Maxtor Corporation
500 McCarthy Boulevard
Milpitas, CA 95035 USA

To: T10 SAS Protocol Working Group
Contact: Mark Evans
Phone: 408-894-5310
Email: mark_evans@maxtor.com
Date: 19 December 2003

Subject: SAS-1.1, adding the Terminate Data Transfer protocol service

Figure 1 — ST_I (transport layer for SSP initiator ports) state machines

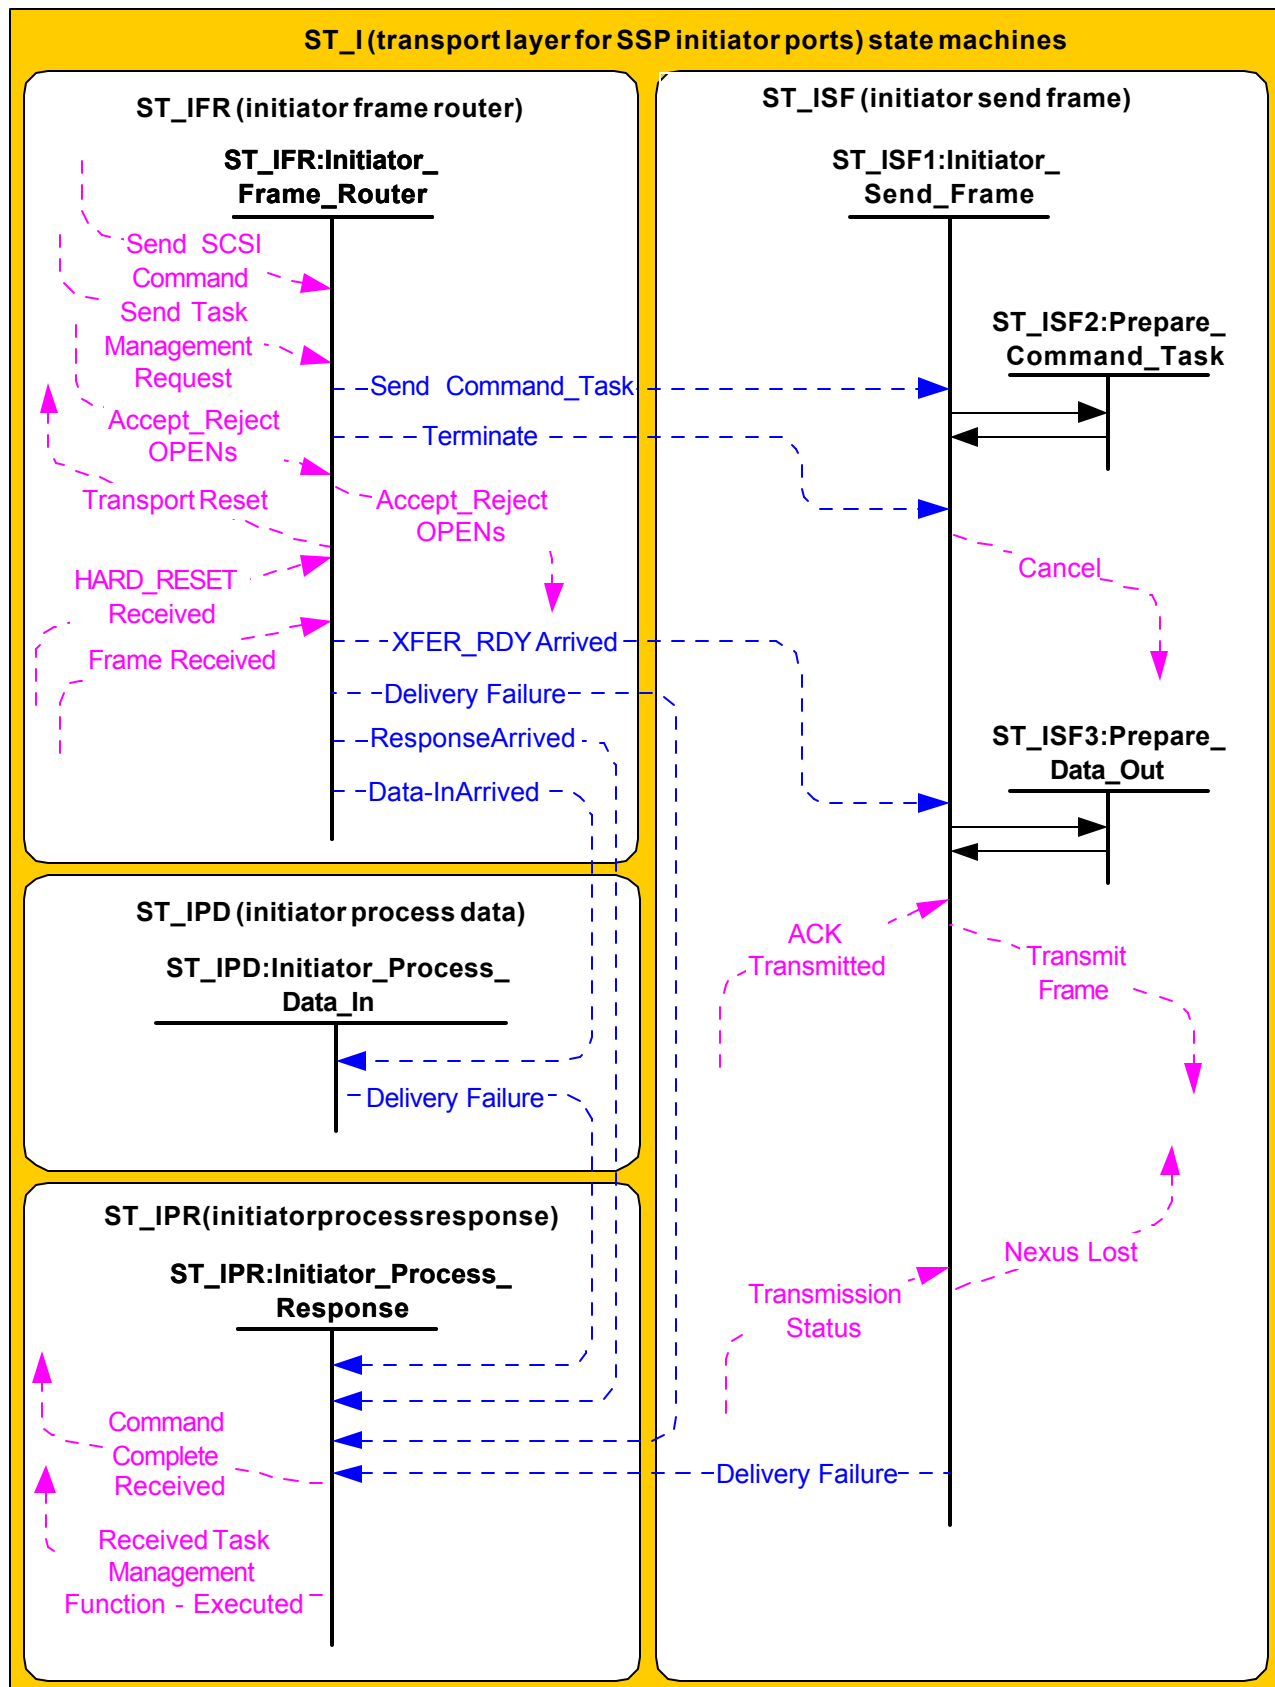
Item 7) In order for tasks to be cleared from SSP initiator ports after a task management request affecting that task has been received, it is necessary for the ST_IFR:Initiator_Frame_Router state machine to be aware of outstanding tasks and task management requests. Because of this, this proposal moves the Send SCSI Command and Send Task Management protocol service requests from being sent to the ST_ISF1:Send_Frame state machine to being sent to the ST_IFR state machine. This makes it so that the flow of the text in the draft standard is better if the ST_IFR description precedes the ST_ISF1 description. The following proposed text makes those changes along with some other editorial changes (note also that the ST_IFR state machine no longer terminates). The following begins with clause 9.2.6.1.

If the request is a Send SCSI Command transport protocol service request, and the request causes one or more outstanding tasks in the port to be cleared or aborted (e.g., PREEMPT), then this state shall send a Terminate message to any ISF state machine that is processing one of the affected tasks.

If the request is a Send Task Management Request transport protocol service request, and the request causes one or more outstanding tasks in the port to be cleared or aborted, then this state shall send a Terminate message to any ISF state machine that is processing one of the affected tasks.

If this state machine receives a HARD_RESET Received confirmation, then this state shall send a Transport Reset event notification to the SCSI application layer and send a Cancel message to any ISF state machine processing a task.

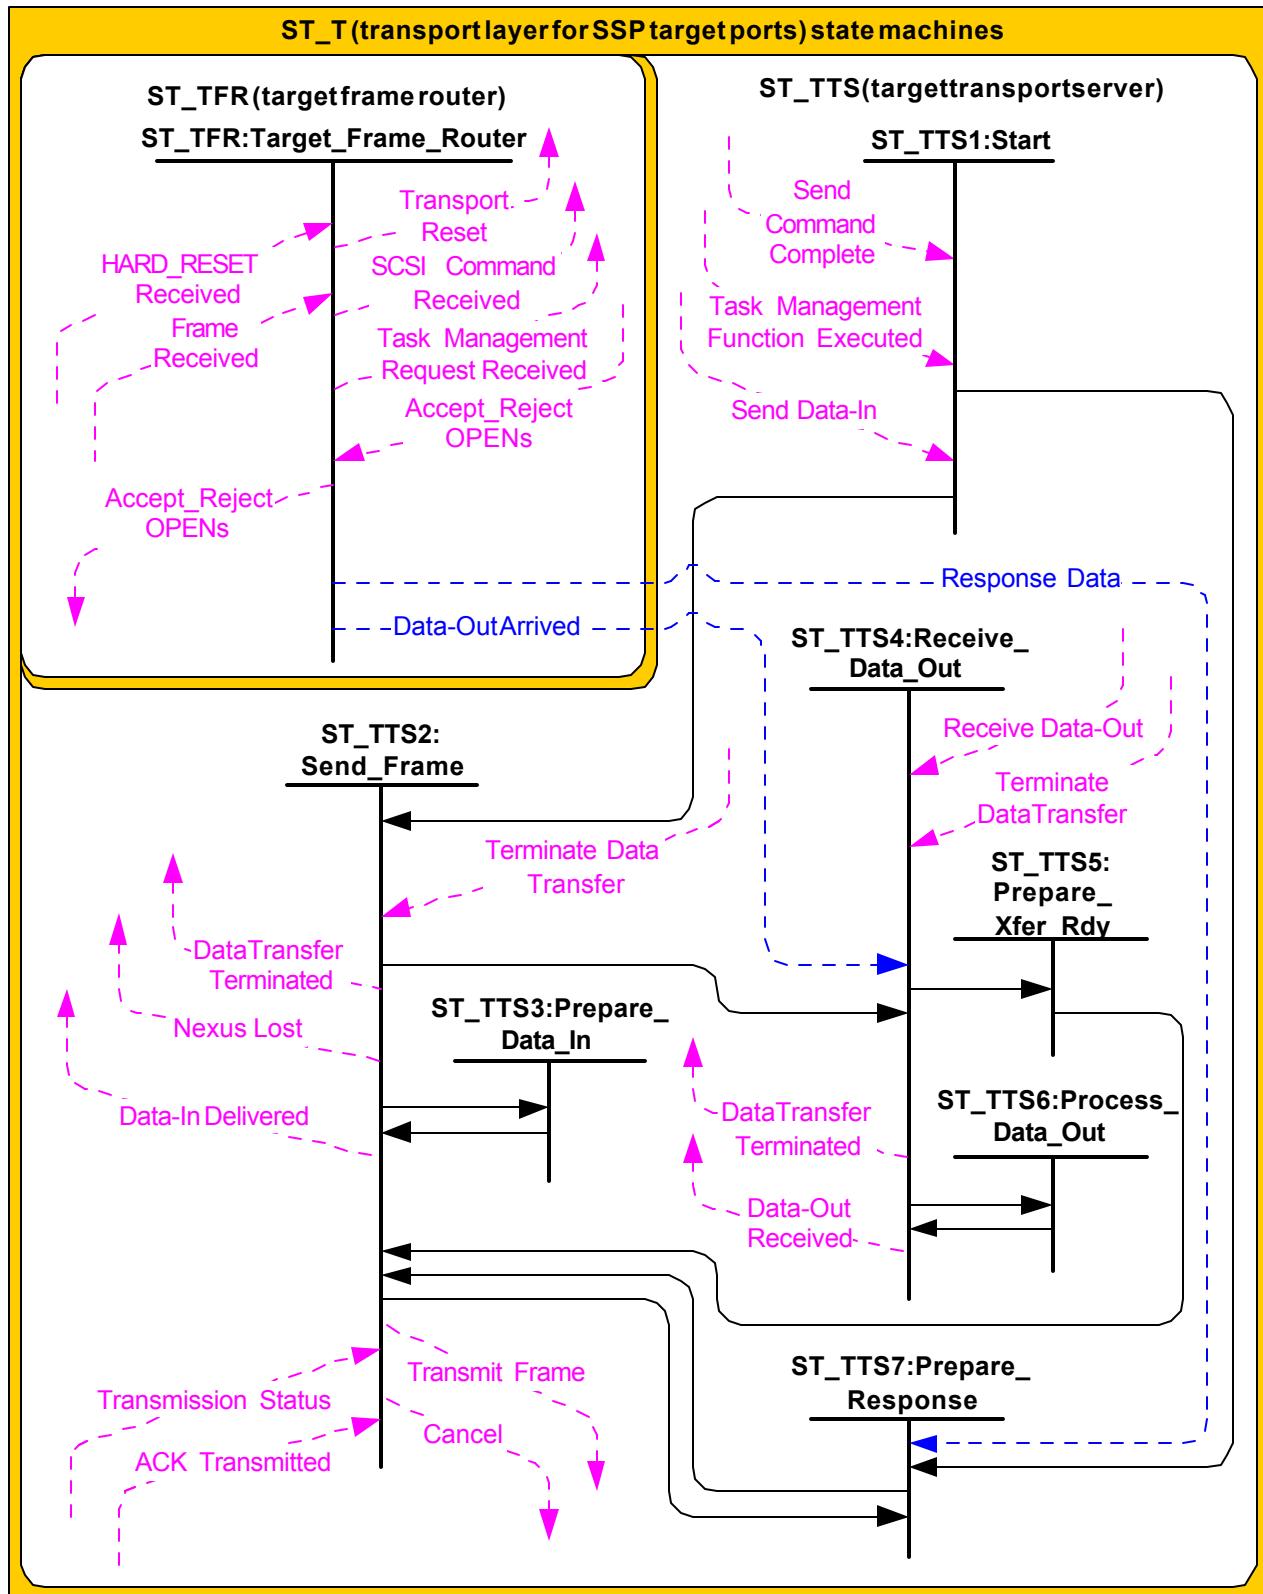
Item 8) In Figure 114 - ST_T (transport layer for SSP target ports) state machines in clause 9.2.6.3.1 ST_T state machines overview add:

- a) a Terminate Data Transfer request from the application layer to ST_TFR:Target_Frame_Router;
- b) a Data Transfer Terminated confirmation from ST_TFR:Target_Frame_Router to the application layer;
- c) a Terminate message from ST_TFR:Target_Frame_Router to ST_TS2:Send_Frame; and
- d) a Terminate message from ST_TFR:Target_Frame_Router to ST_TTS4:Receive_Data_Out.

These changes are shown in the following figure.
